**ON-SITE SEWAGE DISPOSAL SYSTEM  
HOWARD COUNTY HEALTH DEPARTMENT  
BUREAU OF ENVIRONMENTAL HEALTH**

SUBDIVISION: Shepards Glen

ADDRESS: 3901 Walt Ann Drive

TRENCHES:	Trench to be _____ feet wide. Inlet _____ feet below original grade. Bottom maximum depth _____ feet below original grade. Effective area begins at _____ feet below original grade. _____ feet of stone below distribution pipe.
LOCATION:	
PURPOSE:	Existing septic system has failed. Call for inspection when ground is opened so sanitarian can recommend repair.

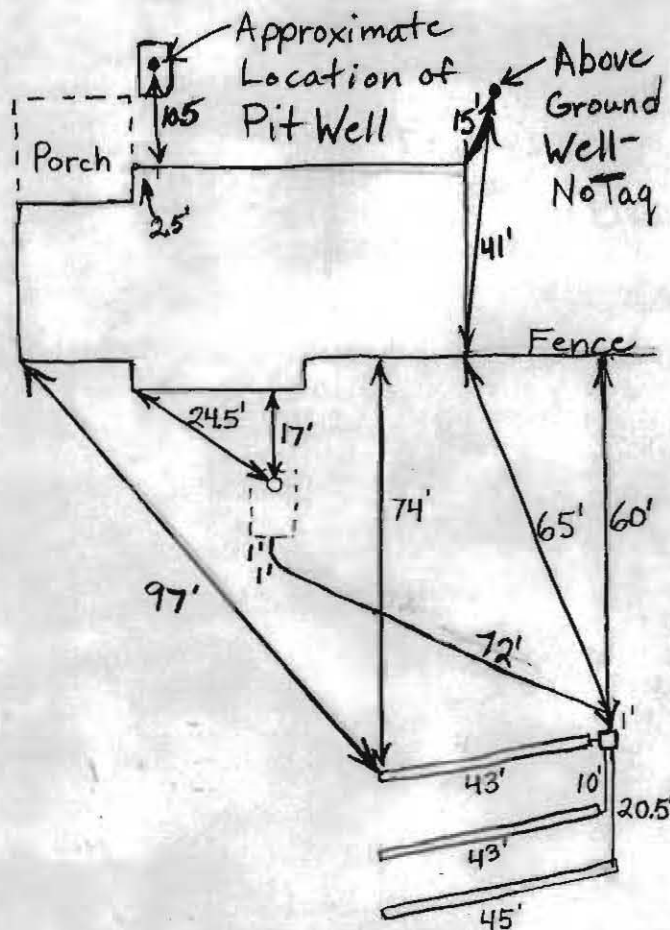
PRE-CONSTRUCTION 5/2/05 To install 3 - 40' trenches 10' from right property line. Stay 100' from all wells. Must locate.

INSTALLATION neighbors well. Pump out and fill in drywell. (BB)

5/6/05 Neighbors well located and > 100' from trenches. Drywell pumped out and filled with dirt. O.K. to cover everything. (BB)
